STREET A PLAN AND
PROFILE

PARKER RIDGE
82 SCHOOL STREET
ROLESVILLE / NORTH CAROLINA / 27571

08/01/2023 PER TOWN OF ROLESVILLE COMMENT

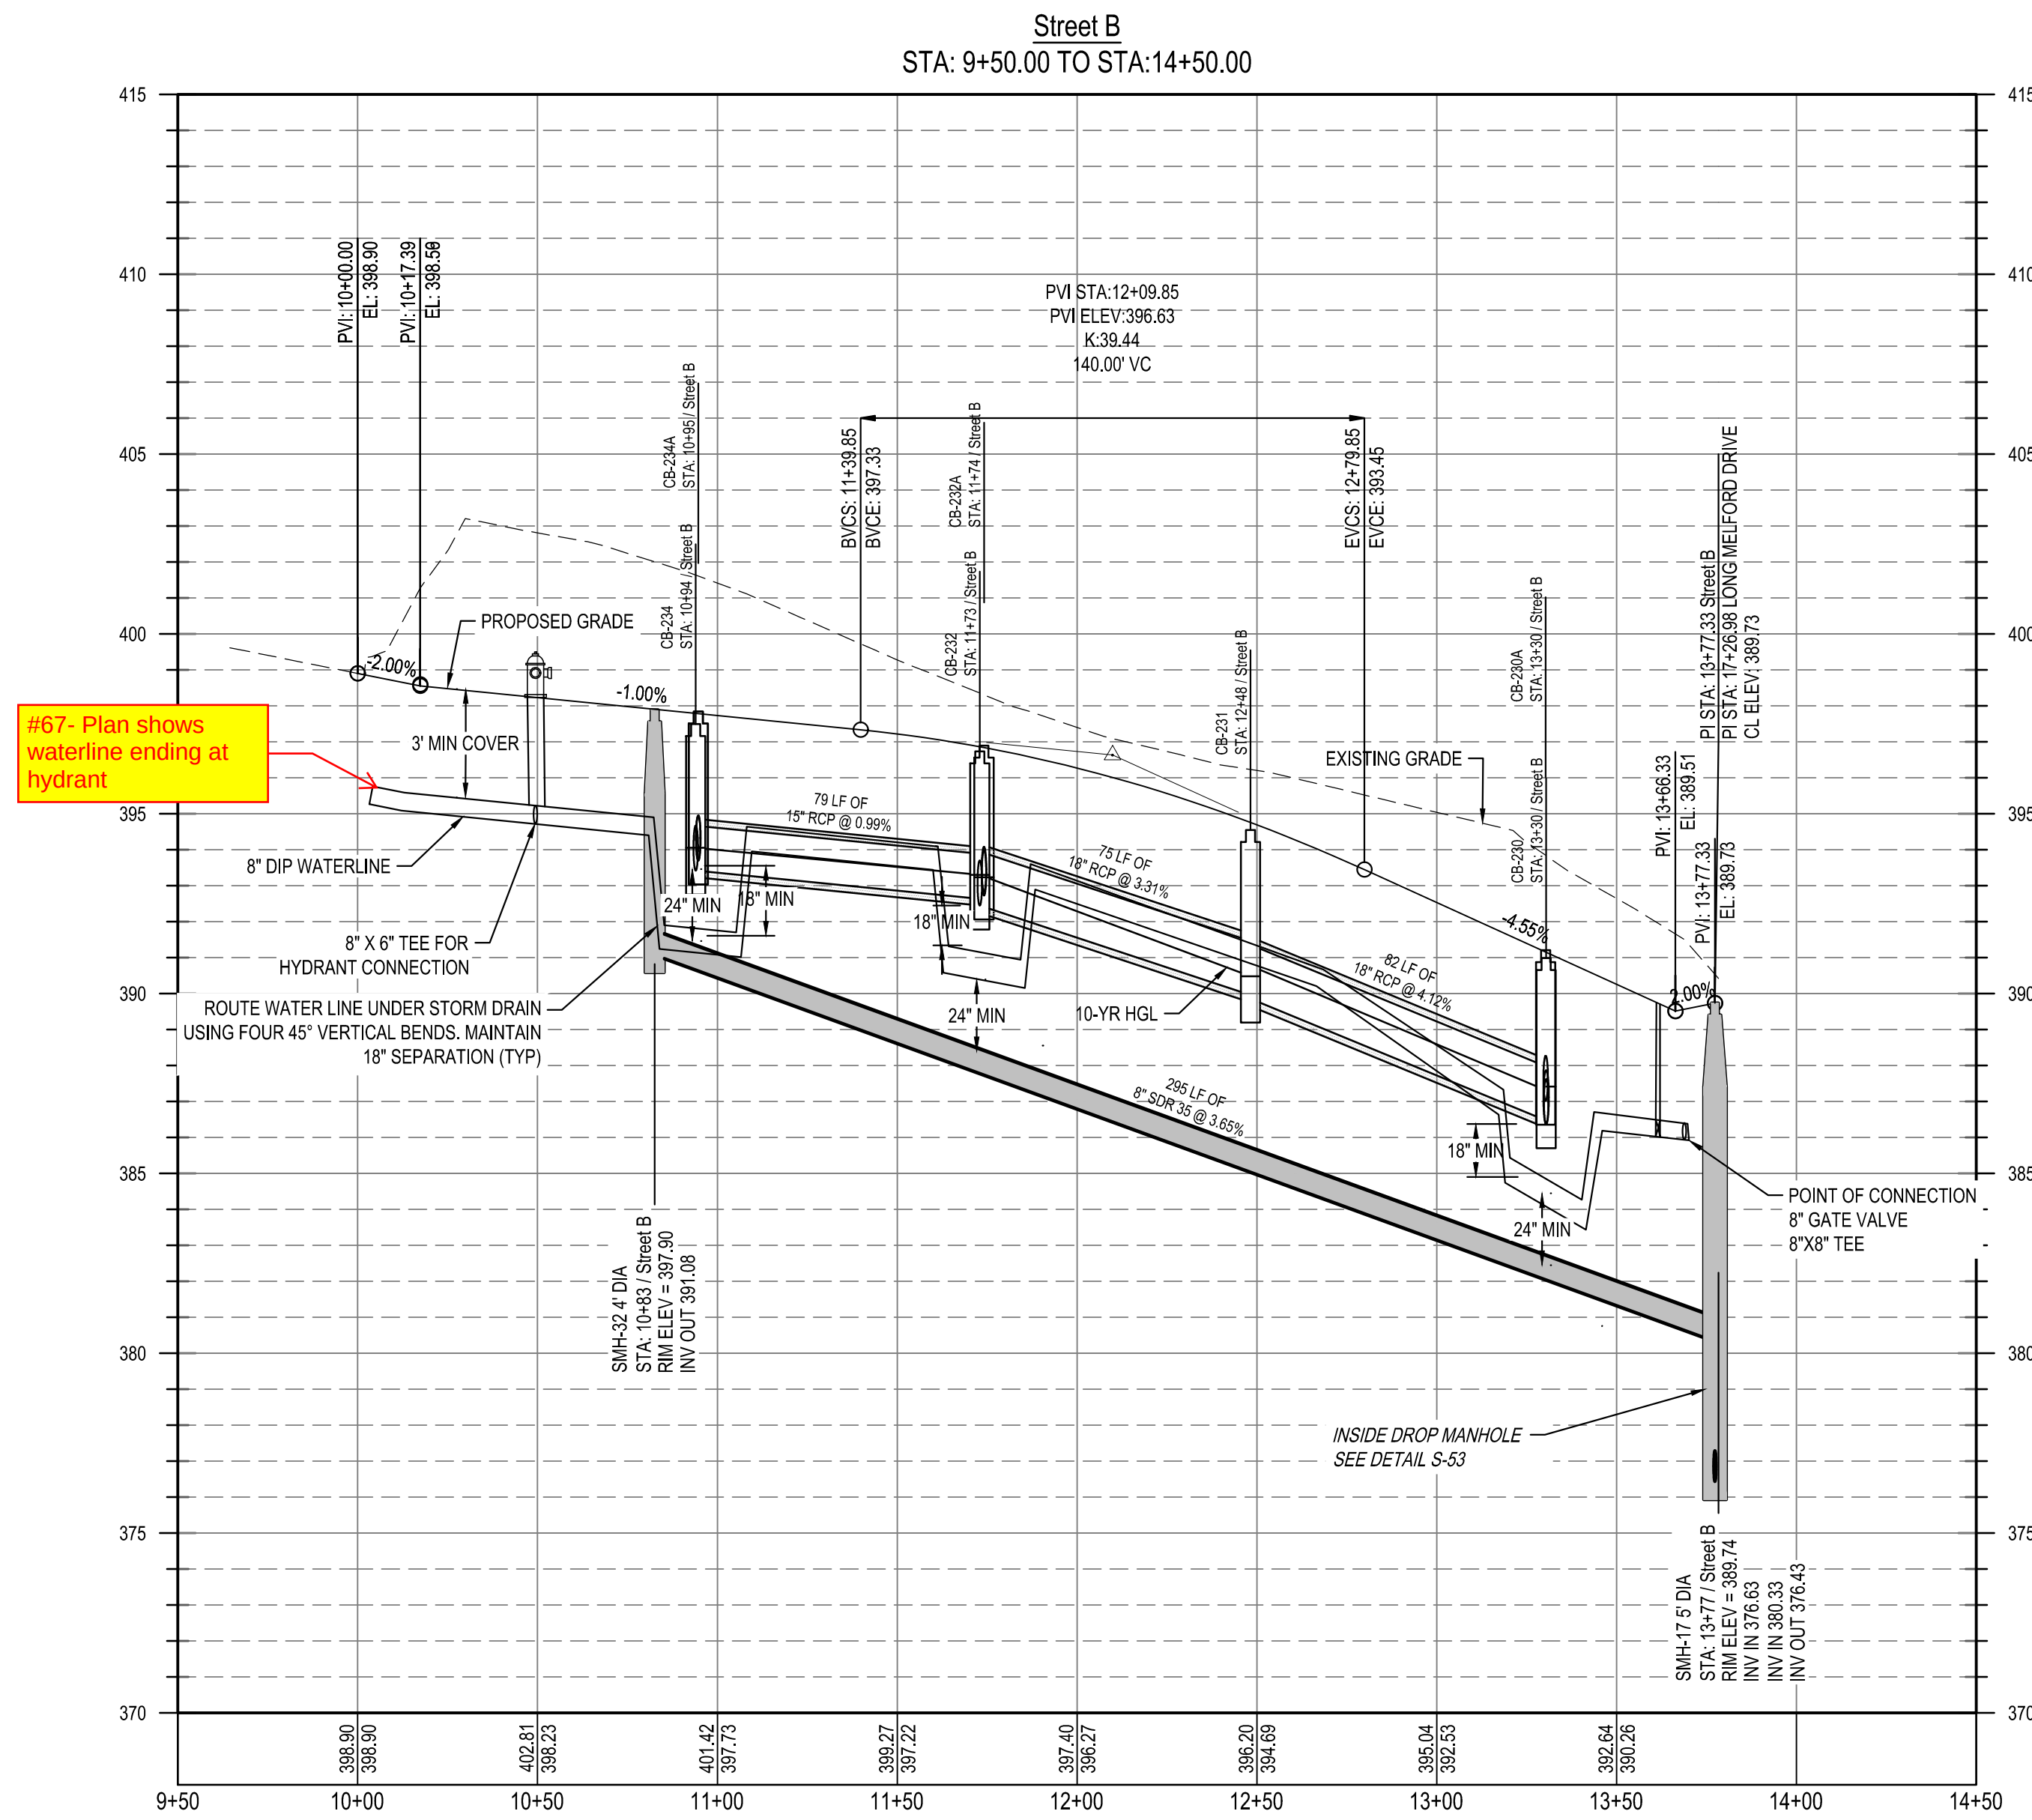
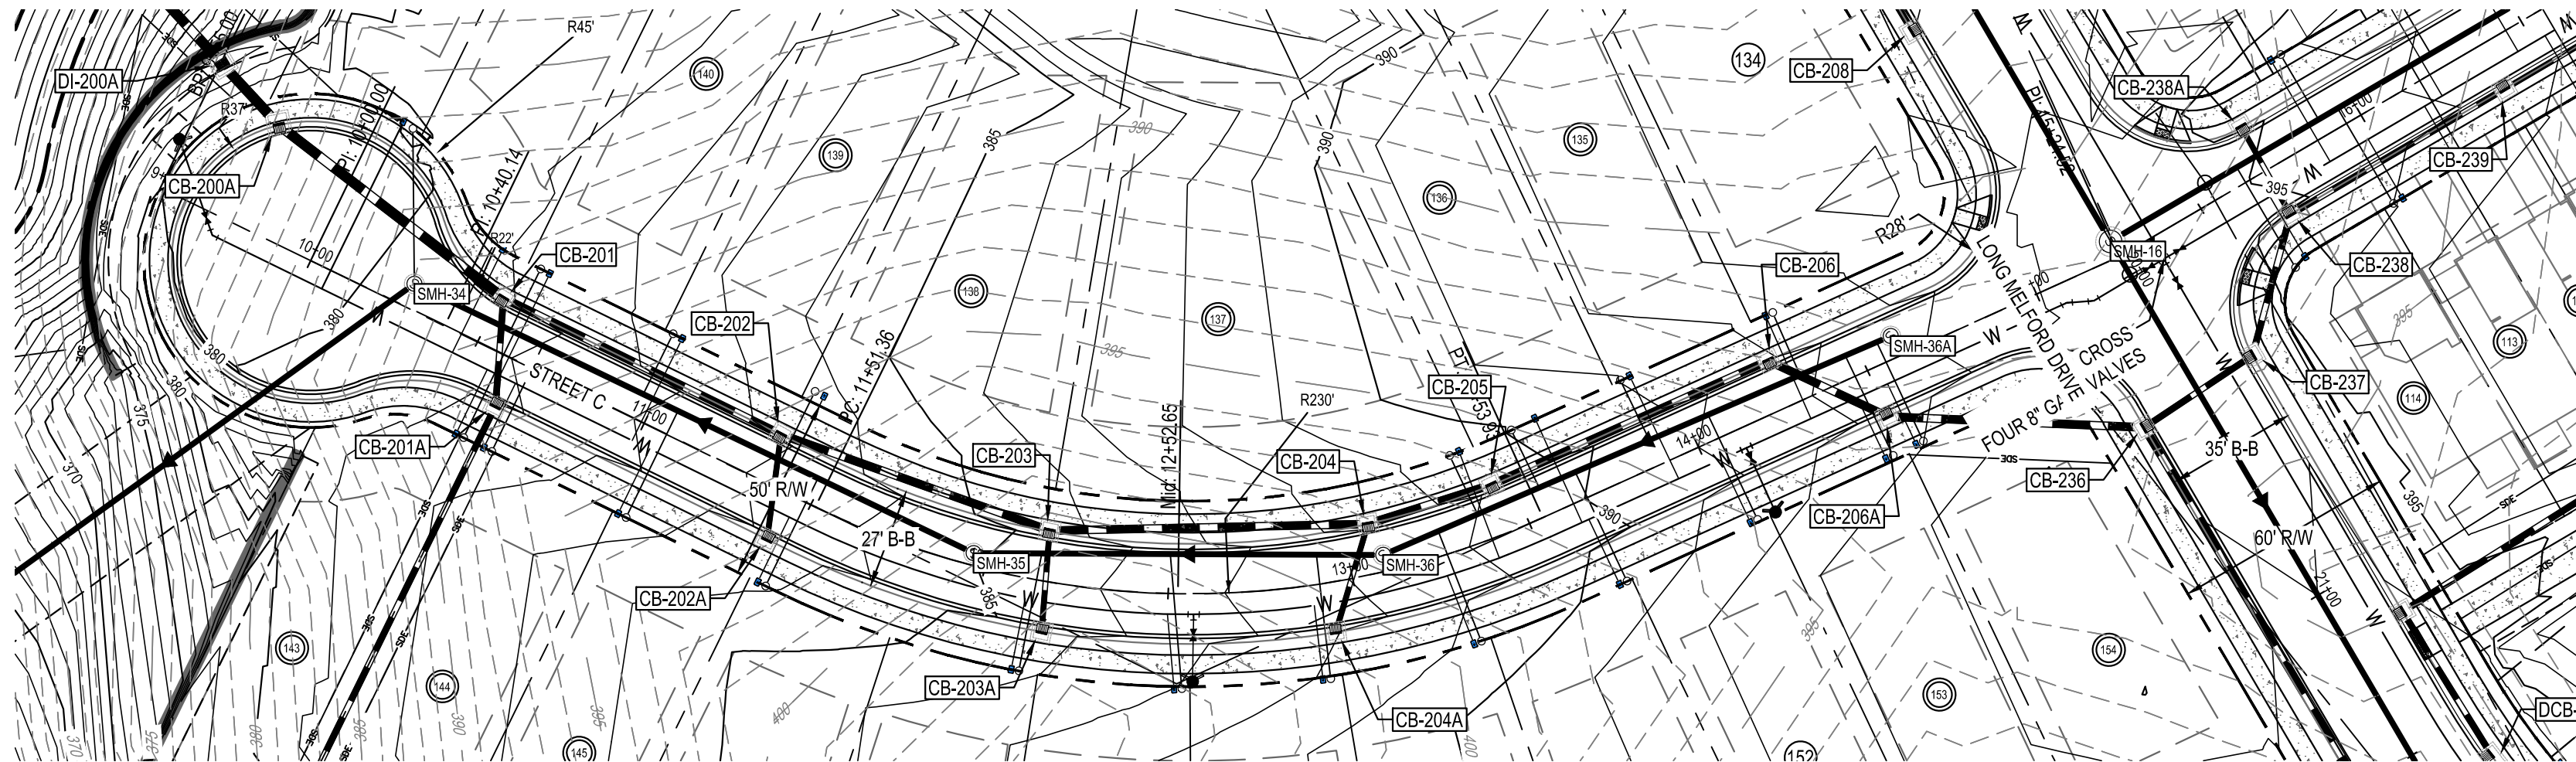
#62- There are several locations where the dimensions don't seem to line up with top/bottom of pipes. Please make sure it is clear what is being dimensioned. If crossings are not meeting minimum requirements, design will need to be adjusted.

#62- There are several locations where the dimensions don't seem to line up with top/bottom of pipes. Please make sure it is clear what is being dimensioned. If crossings are not meeting minimum requirements, design will need to be adjusted.
